Zoning Commission

Case Number: SP-21-023

Site Plan Amendment

Site Location: 3033 Morton Street

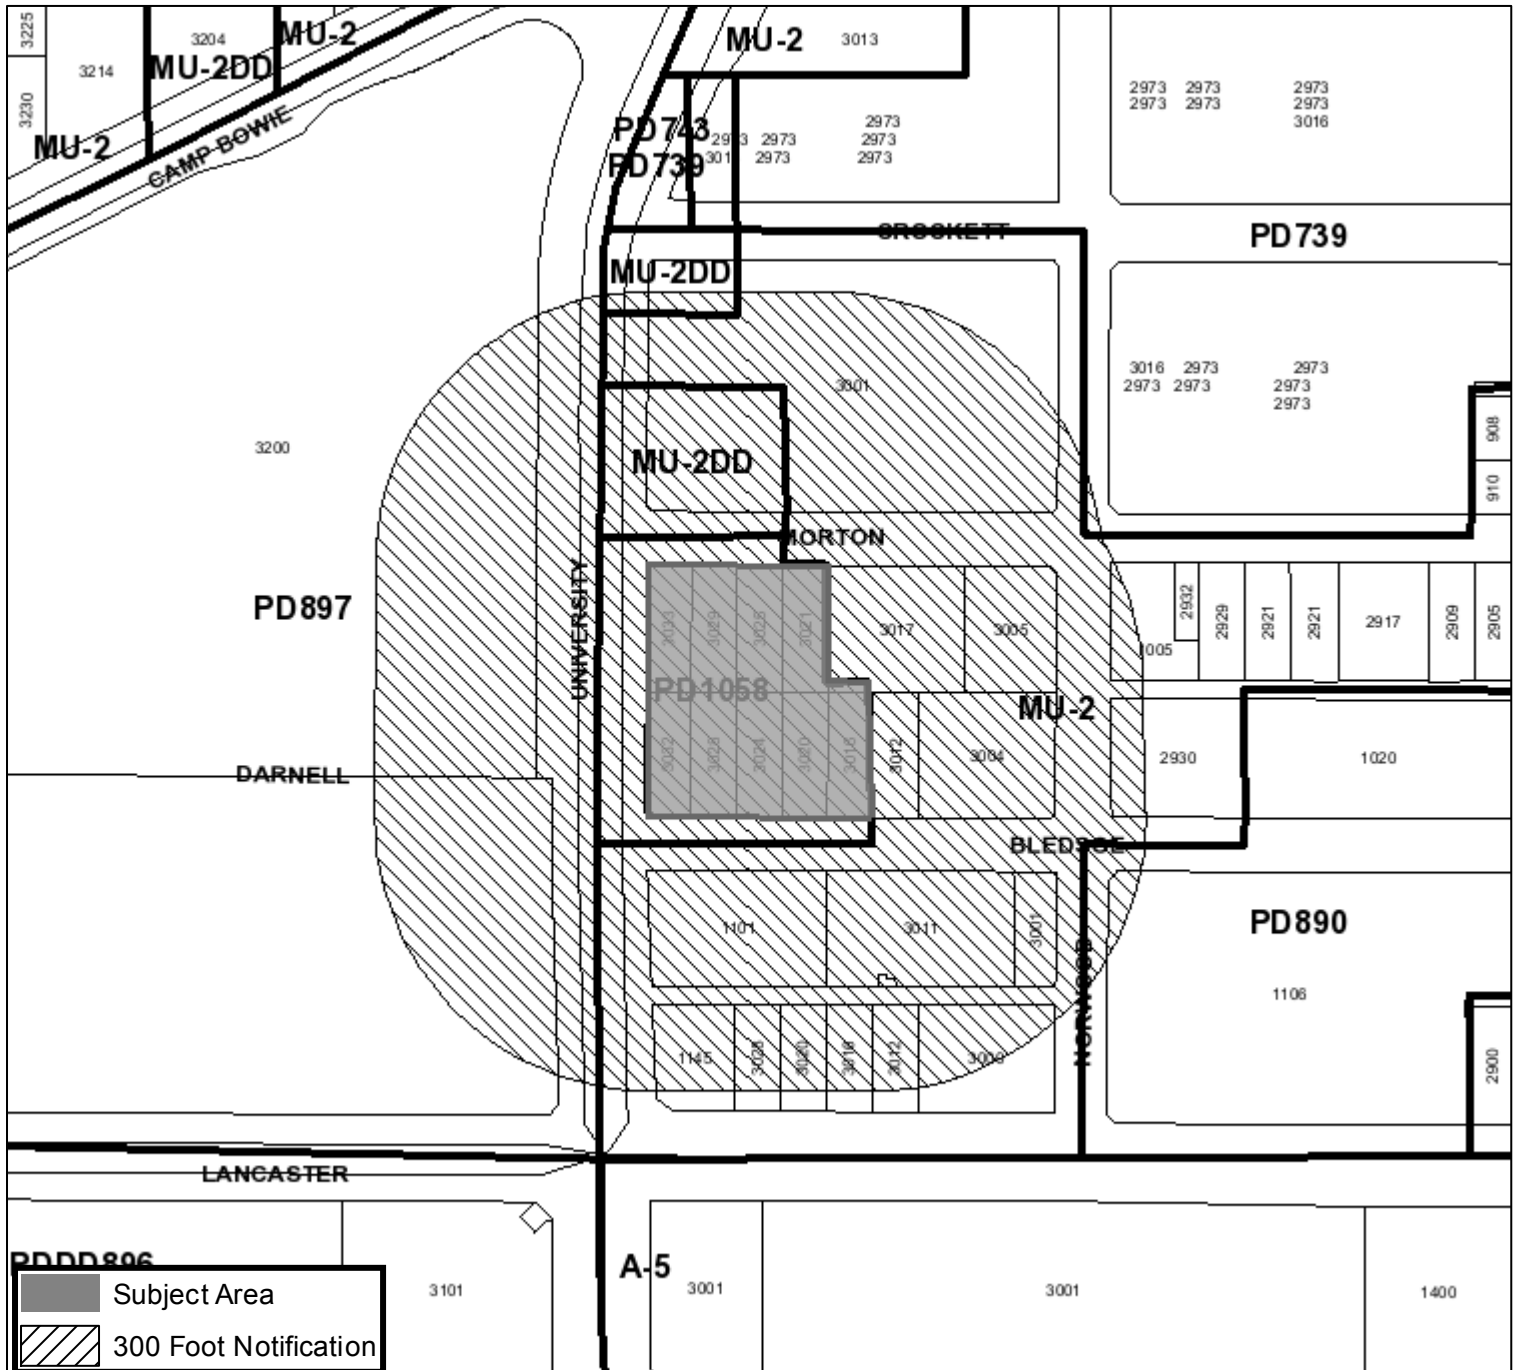
The original site plan had the hotel facing University Boulevard with Morton and Bledsoe Streets as secondary street. The parking was tucked at the rear (east elevation) of the building with access to Morton and Bledsoe. The parking had minimum frontage on the secondary streets.

The proposed site plan meets the above standards; however, at the last the Zoning Commission meeting (to be approved by City Council October 12, 2021) it was recommended to City Council that the standards be changed:

The western portion of the site located in PD 1058 conforms conceptually to MU-2 standards adopted in 2018 and thus staff is recommending **approval**. The remainder of the site (Zoned MU-2) will need to conform to the recently adopted MU-2 standards. It is staff's understanding that the applicant is proposing pedestrian garage parking along all of the secondary streets. This would not meet the new MU-2 standards nor does it meet the following guiding principles of the MU-2 ordinance:

At the time of permitting the applicant will either need to conform to the MU-2 standards or ask for a waiver from the Urban Design Commission (UDC).
